# **Oakdale Planning Proposal**

## **Flood Constraints Assessment**

**Rev B**

**March 2025**

FIGURE 5-1

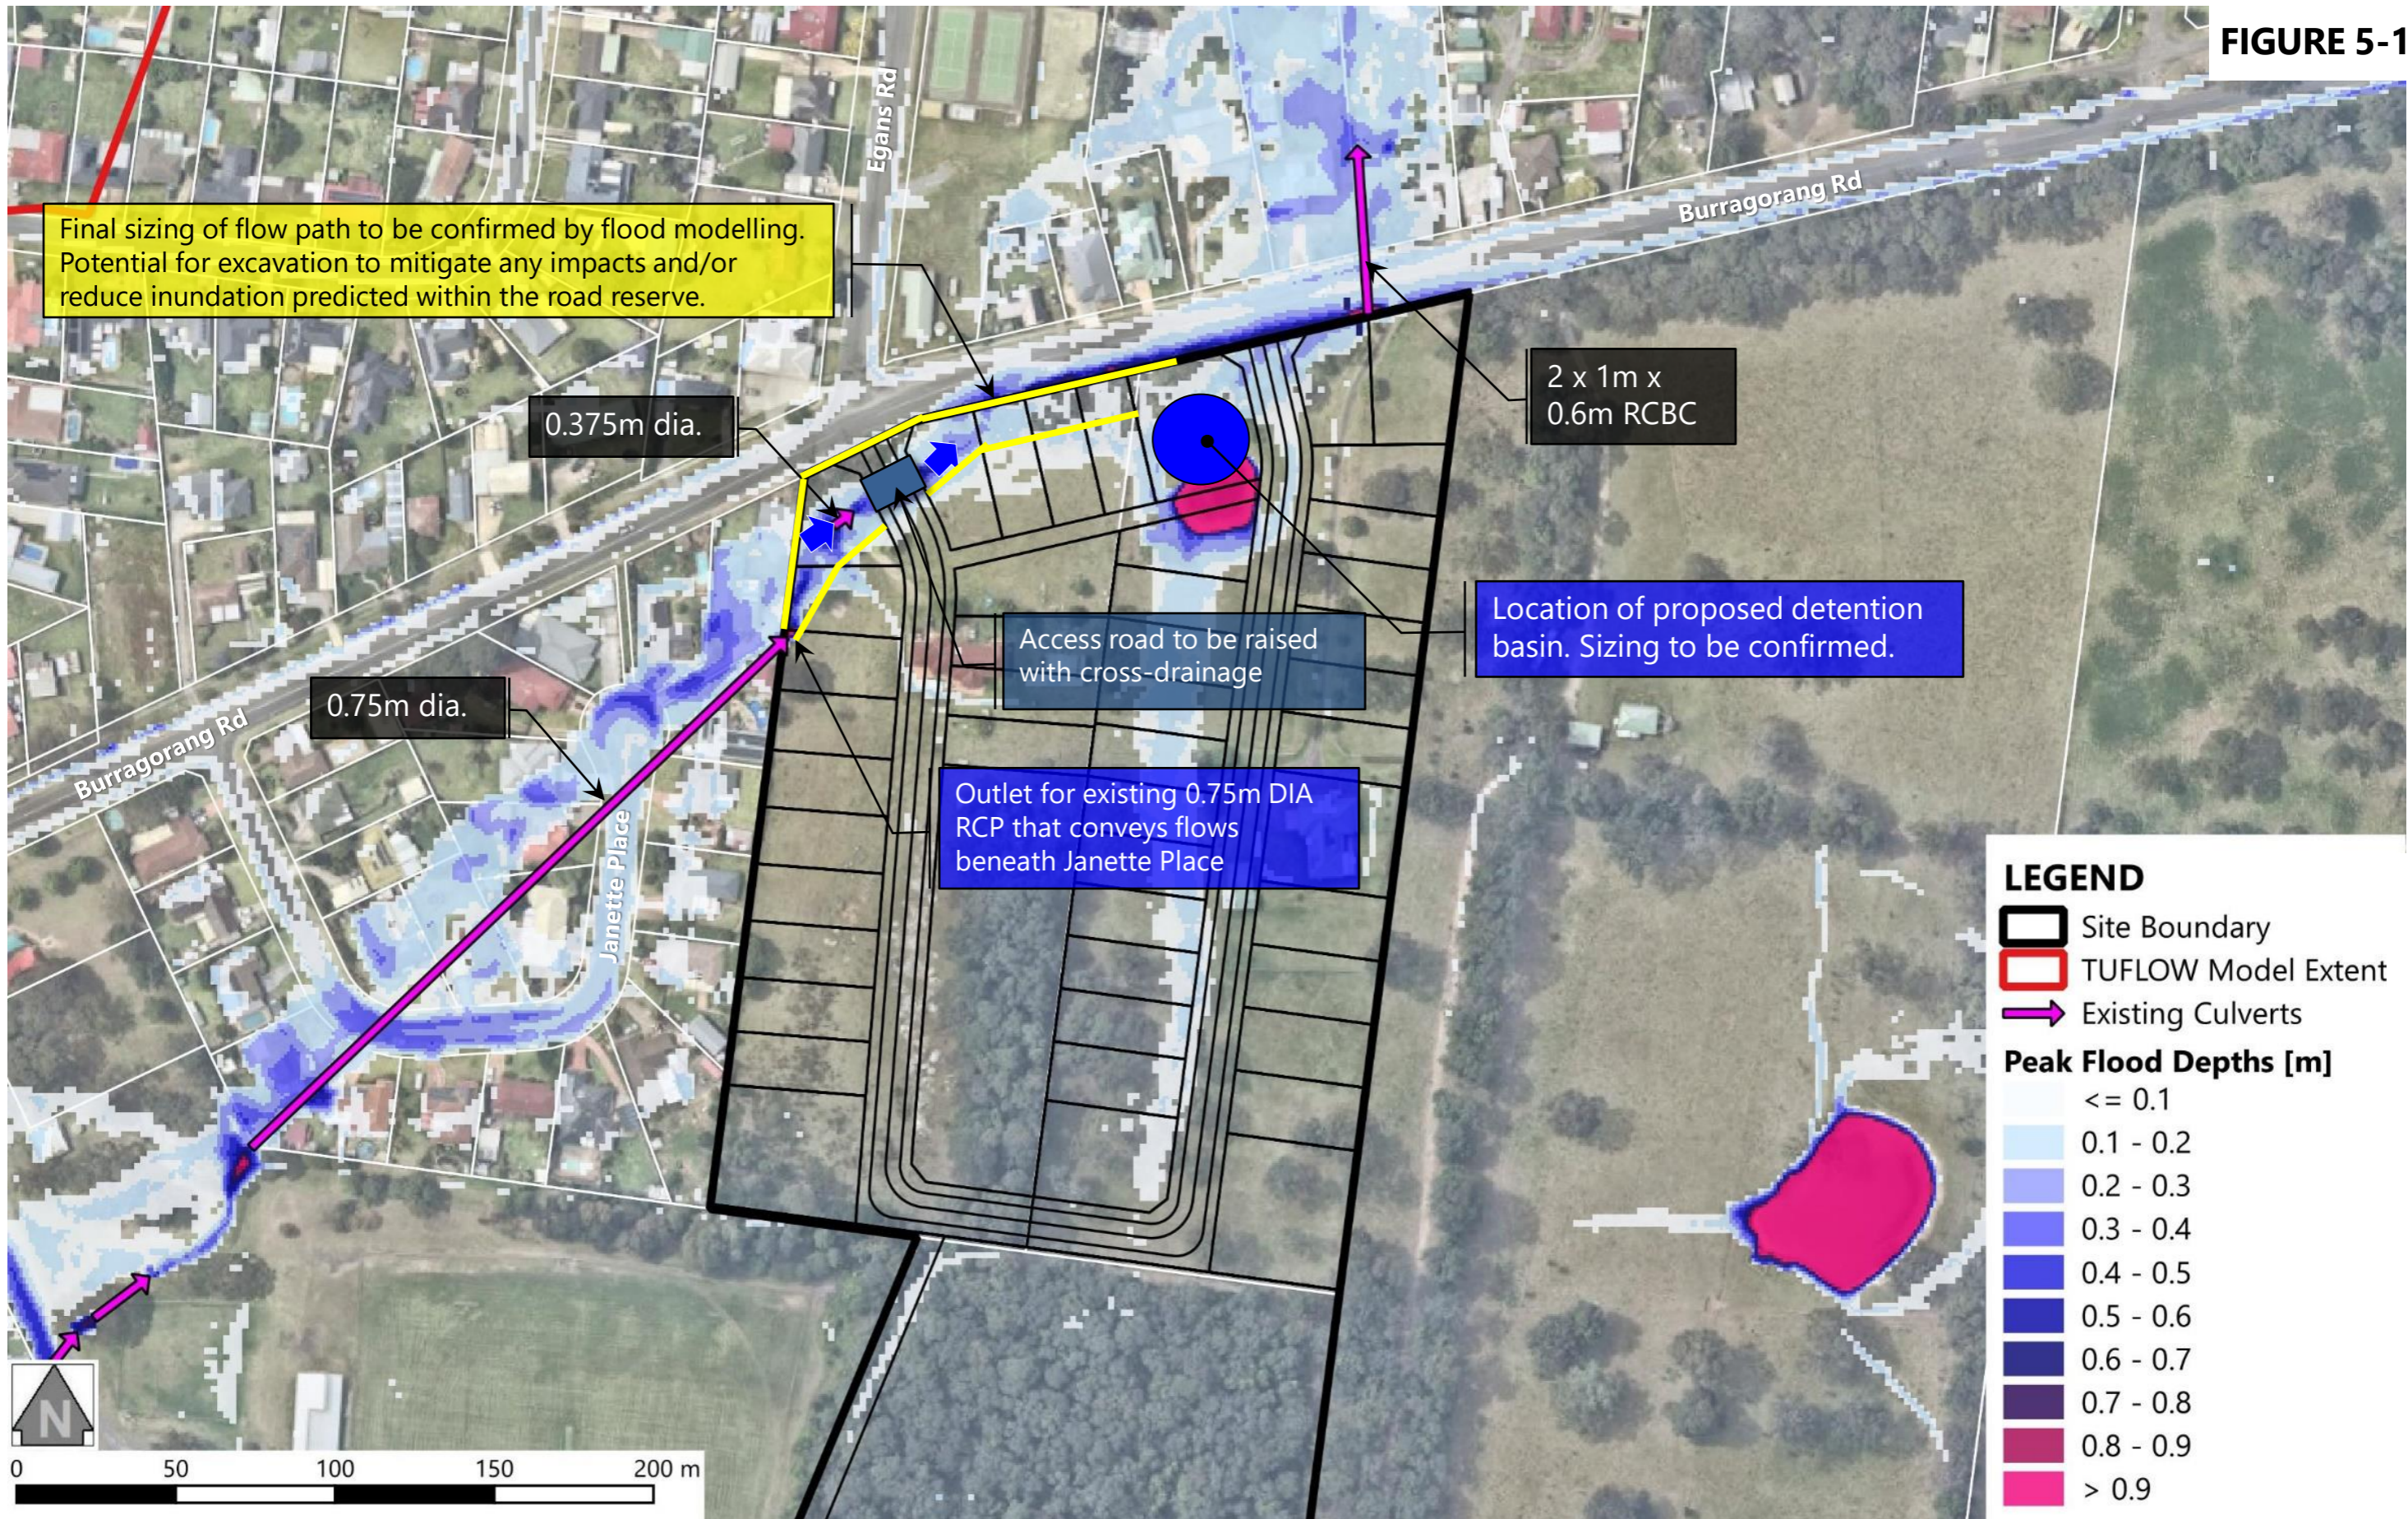
It is recommended that the lot layout be modified adjacent to Burragorang Road to allow land to be reserved for the safe passage of floodwaters. This should be based on considering floods up to and including the 1 in 500 AEP event to ensure there are no significant impacts on adjoining properties. It is also recommended that modelling be undertaken for the PMF event to ensure the development does not result in an increase in the potential risks to those that might seek to evacuate the area in the occurrence of a very rare flood.

The extent of the site that is recommended to be reserved for flow conveyance is shown in **Figure 5-1**. Minor excavation could be undertaken along this flow path to reduce any potential impacts caused by the development. This excavation could also act to reduce the frequency of floodwater overtopping Burragorang Road by removing a proportion of the flow that would otherwise enter the road reserve. The benefits afforded by this proposal would be subject to detailed modelling.

It is understood that MoreHuman is receptive of these recommendations and as such, has updated the Masterplan (refer **Appendix A**) to conceptually include a proposed overland flow path. Post-development flood modelling could be undertaken to confirm the required dimensions of the flow path, and any benefit that excavation along its alignment could afford in the way of reducing the frequency of flood affectation within the Burragorang Road corridor.

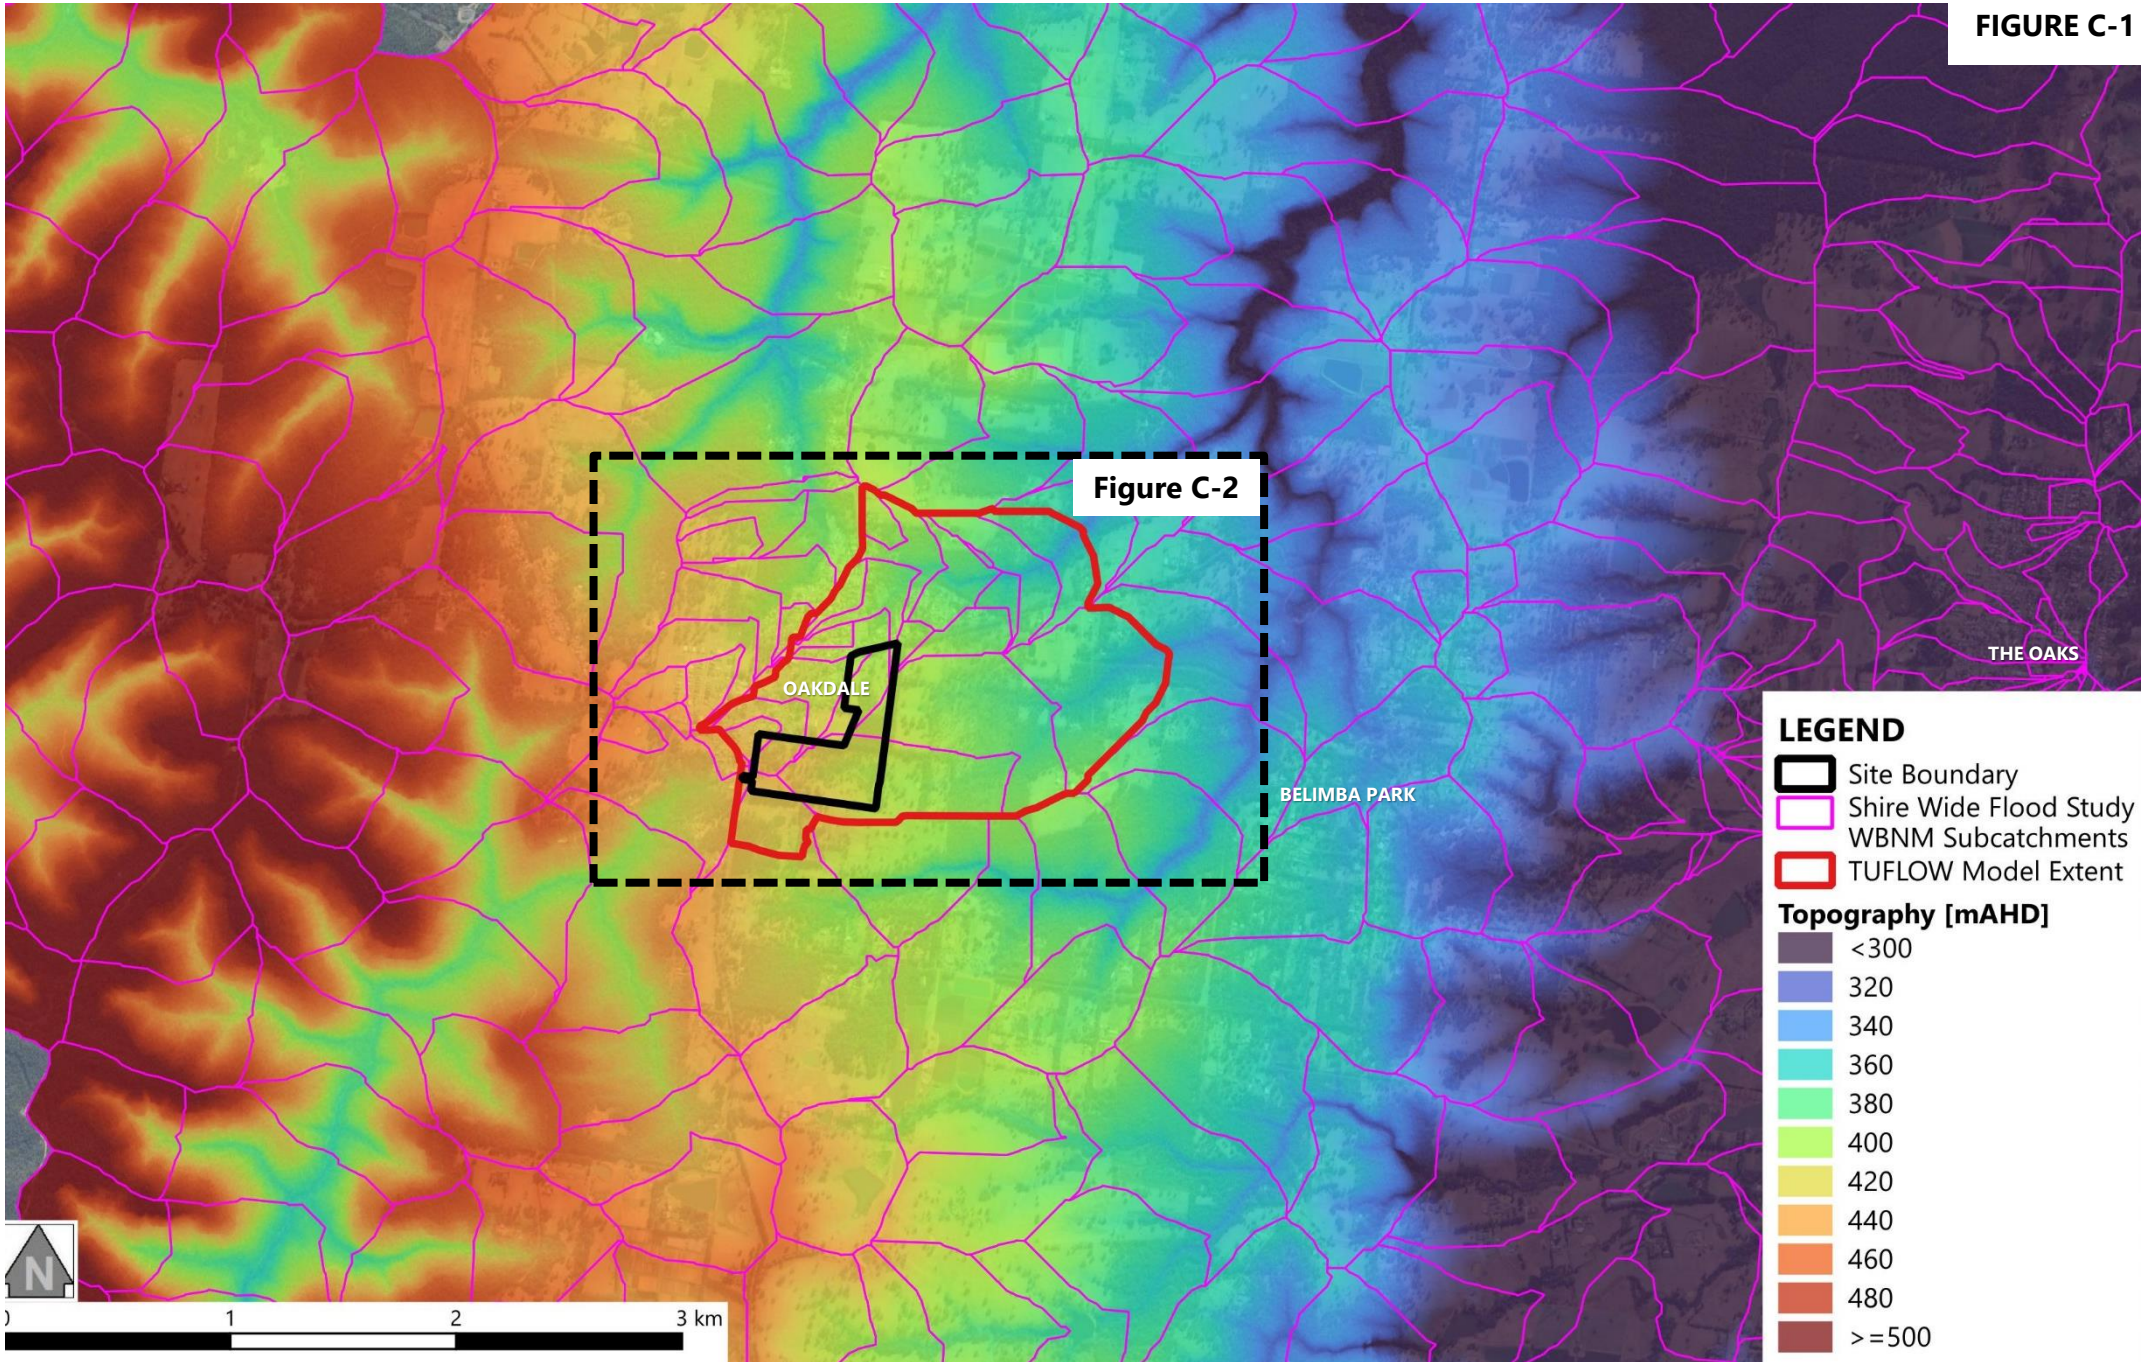
BCS also provides the following comments on the 1% AEP flood maps provided in Appendix D:

- The maps of the post-development scenario should show the proposed zoning as depicted in Figure 10 of the PP Report instead of the existing undeveloped scenario
- The flood hazard maps (Figures B003 and C003) may require revision as areas shown in Figures B001 and C001 that have flood depth greater than 1m are categorised H1
- Appendix D shows adverse impacts on the downstream community particularly north of Burraborang Road. These impacts should be addressed and mitigated as part of the planning proposal.
